ADDENDUM 1
TO
SPECIFICATIONS, BID AND CONTRACT DOCUMENTS

1st Street SE Revitalization

CITY OF Paris, TX

MTG NO. 246035

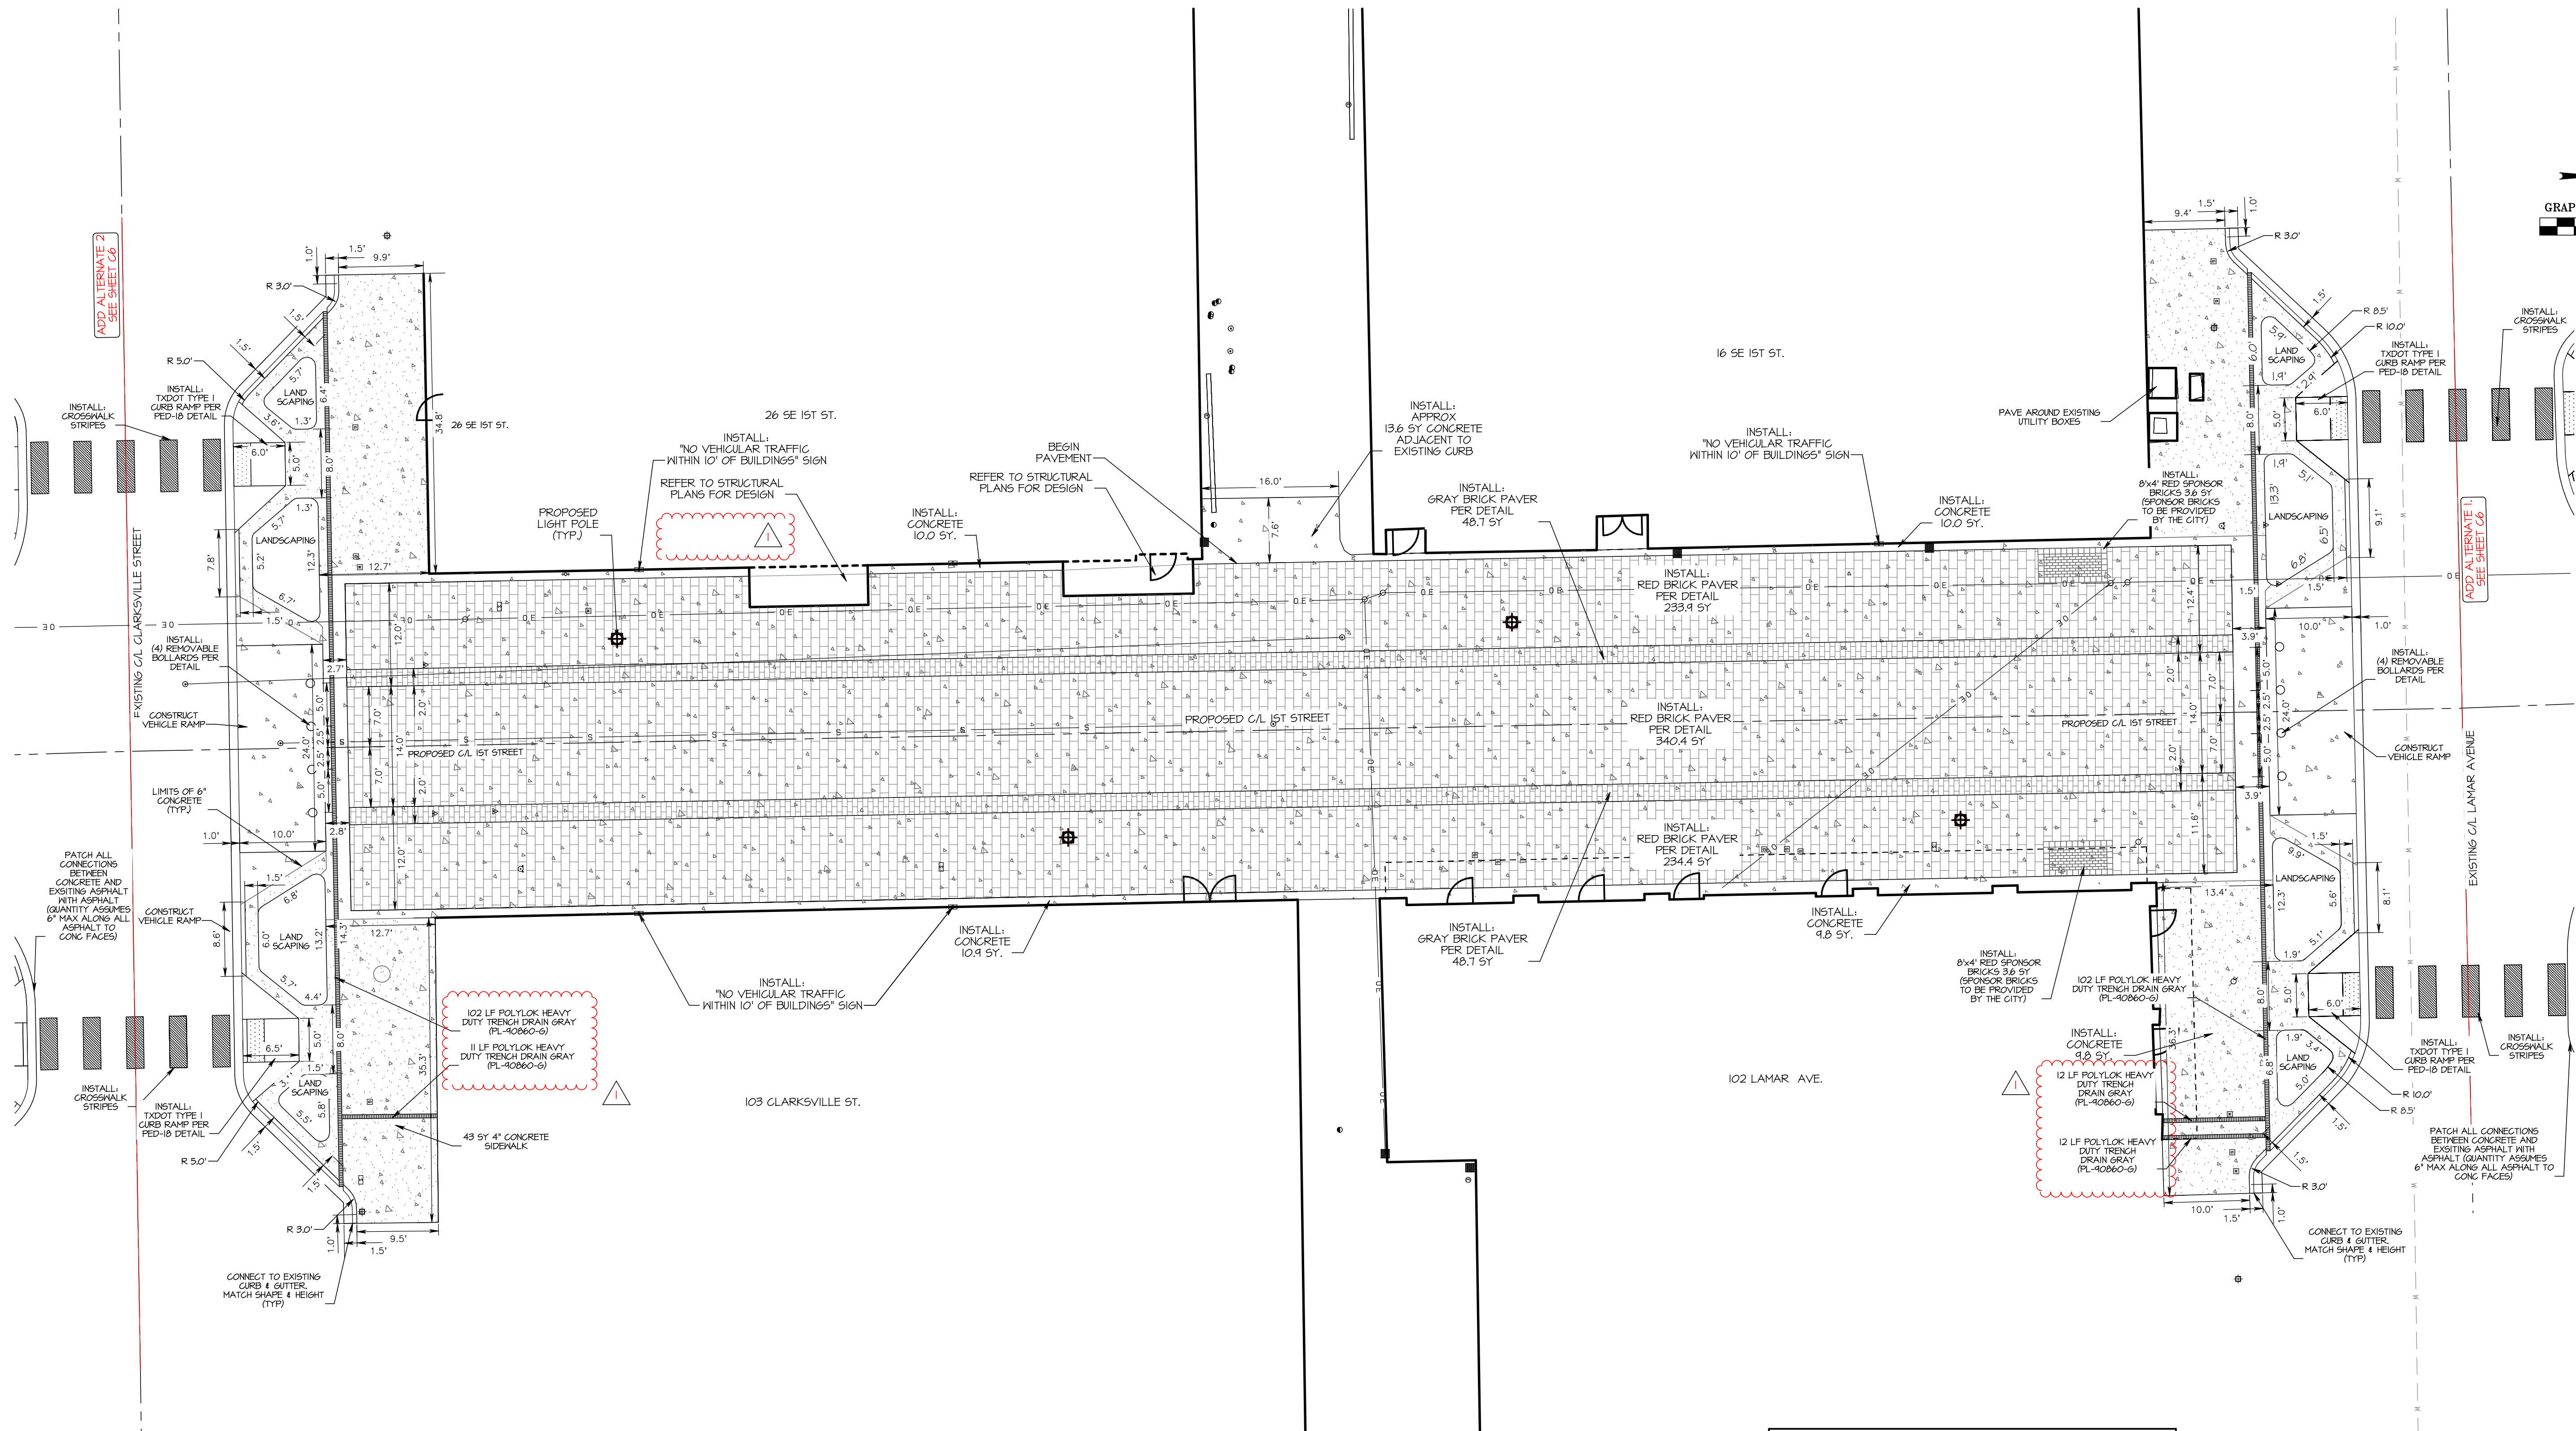
AD-1.3 Plan Sheet C4: Please replace the previous Plan Sheet C4 (Base Bid Dimensioned Site Plan) with the attached Plan Sheet C4 Revision #1.

- Clarified trench drain product code to reflect gray option
- Clarified belgard holland stone in standard finish
- Removed stray pattern shown on west side of paved area

- C1.5: Item 17: Sheet C4 revised to reflect corresponding product code for gray trench drain.**
- C1.6: Concrete Border around Pavers is included in the “Concrete Pavement & Concrete Paver Base (Variable Depth 6” Minimum)” Square Yardage Quantity and shall be constructed monolithically with the concrete base under the pavers**

REVISION #1 NOTES:
CLARIFIED TRENCH DRAIN PRODUCT CODE TO REFLECT GRAY OPTION
CLARIFIED BELGARD HOLLAND STONE IN STANDARD FINISH
REMOVED STRAY PATTERN SHOWN ON WEST SIDE OF PAVED AREA
